# Rezoning Transportation Analysis

Petition Number: 2022-210

**Reviewer:** Patrick Monroe  
Patrick.Monroe@charlottenc.gov  
704-301-1411

Date	Description
05-24-2023	First Review (PDM)

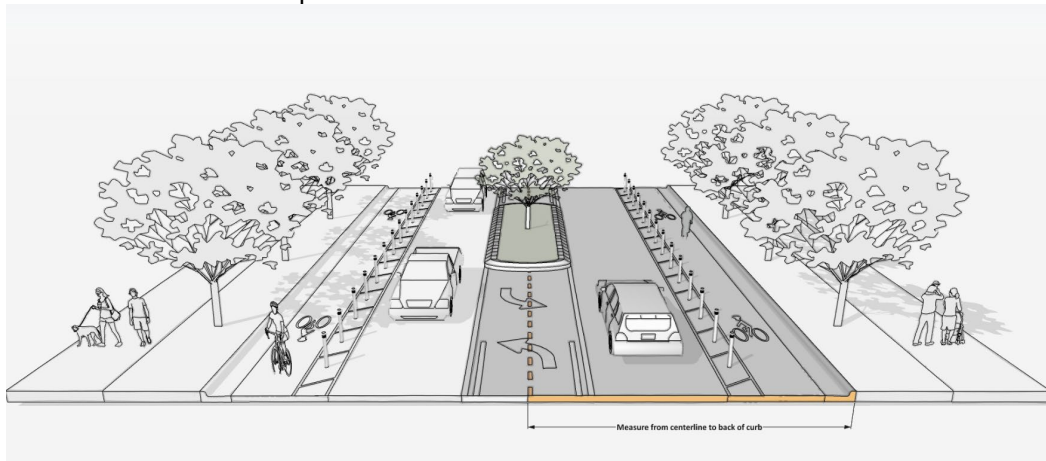
- a. **South Tryon Street:** Location of curb and gutter to be moved a minimum of 42.5 feet from roadway centerline to accommodate the Charlotte Streets Map with a roadway typical section of a 4+ Avenue with Buffered/Separated Bike Lanes and On-Street-Parking..

- b. **Clanton Road:** Location of curb and gutter to be moved a minimum of 27 feet from roadway centerline to accommodate the Charlotte Streets Map with a roadway typical section of a 2+ Avenue with Buffered/Separated Bike Lanes.

**NOTE: Additional distance from center line to back of curb may be required in locations where a median and turn lanes are required. Final curblines to be reviewed by CDOT once TIS is approved.**

Label and dimension the curb and gutter from the centerline for each road on the site plan.
